**Re: Revised Slope Assessment and Setback Requirements to Support the Application of Official Plan and Zoning By-law Amendments
Lovesick Lake Beach Resort
3340 Strickers Lane, Selwyn, Ontario
D.M. Wills Project No. 18-10844**

technical review comments were received from ORCA as summarized in their *Appendix A: Technical Services Memo* (File: PPLS-4585 & PPLS-4586), dated November 15, 2022. This Revised Slope Assessment Report addresses these comments, including detailed responses in **Section 5.0**.

5.0 Response to ORCA Comments

Drawing Title
SLOPE STABILITY AND SETBACK PLAN

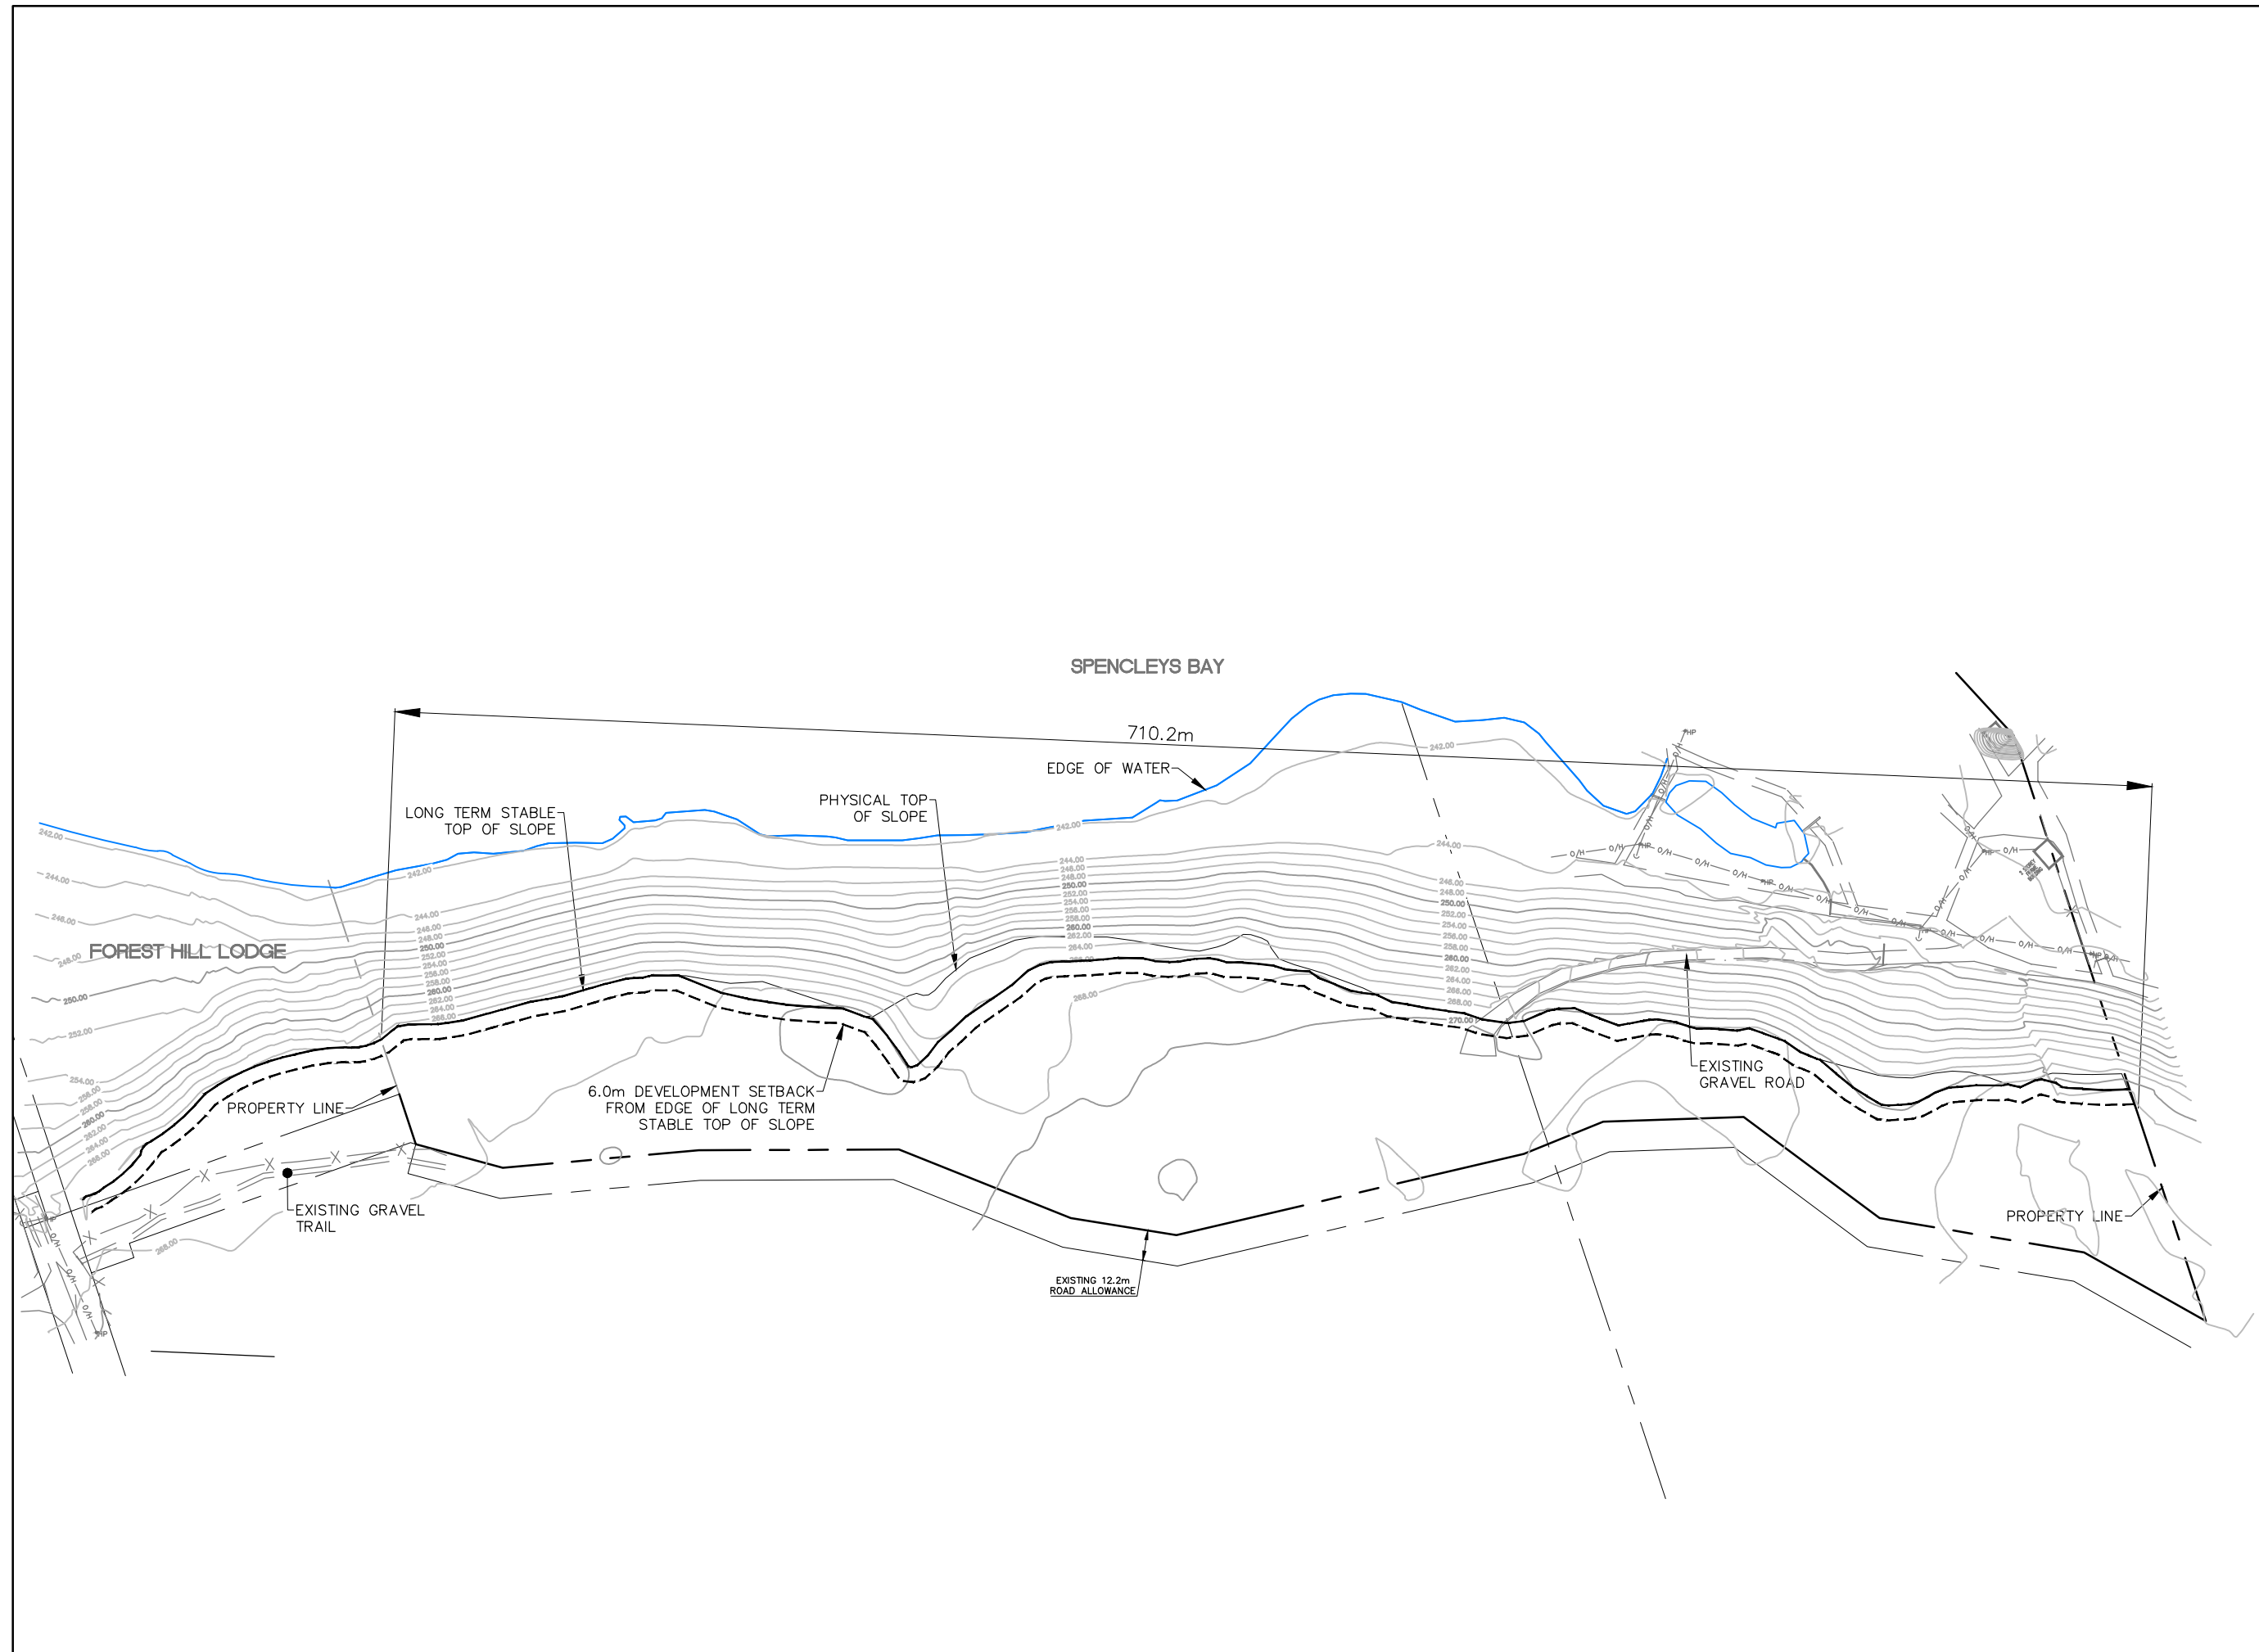
"The LTSTOS plus the 6.0 m Access Allowance needs to be added to the slope between Forest Hill Road and Lot #1. The access road and connection to Forest Hill Road will need to be outside the Erosion Hazard Limit.

Wills completed a second site visit on July 18, 2023, to assess the stability of the section of the slope located between the western limit of the Subject Property and Forest Hill Road. Photographs captured during that second visit are included as Photographs No. 8 to No. 11 in **Appendix C**. Wills findings have been included in the present Slope Assessment, in particular on the Slope Stability and Setback Plan provided in **Appendix A**.

Figure 95 b Confined System, Erosion hazard limit where toe of valley slope is located less than 15 metres from the watercourse

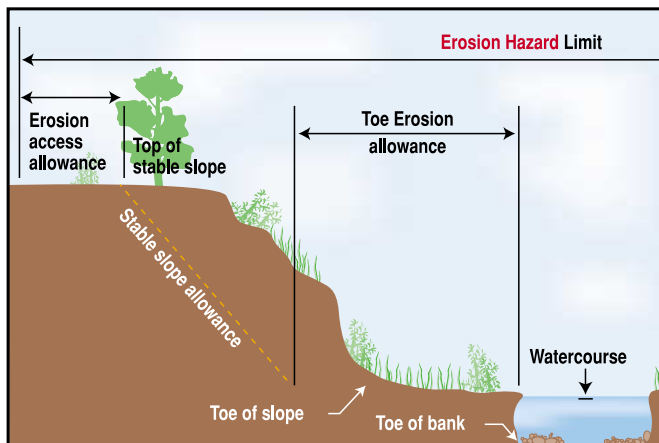
“Within Section 3.1 Slope Assessment, there is reference to the existing slope of 1.5:1 being flatter than the recommended 1H:1V stability gradient. This statement assumes that Otonabee Conservation has agreed to or provided evidence that calcareous bedrock is stable 1:1 slope.”

Based on the existing conditions observed at the toe of slope area (width less than 15 m and no sign of active toe of slope erosion), and Table 3 of the MNR's Slope Guideline, a 2 m toe erosion setback is recommended. The additional 2 m toe erosion allowance does not significantly change the projection of the 1H:1V stability setback and was not applied as a result.

According to ORCA's comment 1.a.i, ORCA relies on the criteria established in the *Technical Guide – River & Stream Systems: Erosion Hazard Limit (MNRF 2002)*. This Technical Guide is based in part on another MNR document from 1998 titled “Geotechnical Principles for Stable Slopes”. Section 4.8 of the latter document indicates that slopes comprised of shale or limestone material generally have a stable inclination of near vertical to 1H:1V. Shallower stable slope inclinations are often reserved for shale bedrock due to its generally friable nature and poor structural properties. Based on Wills' professional experience and site-specific observations, a 1H:1V gradient was considered suitable for the Subject Slope (limestone / dolostone bedrock), and is considered conservative.
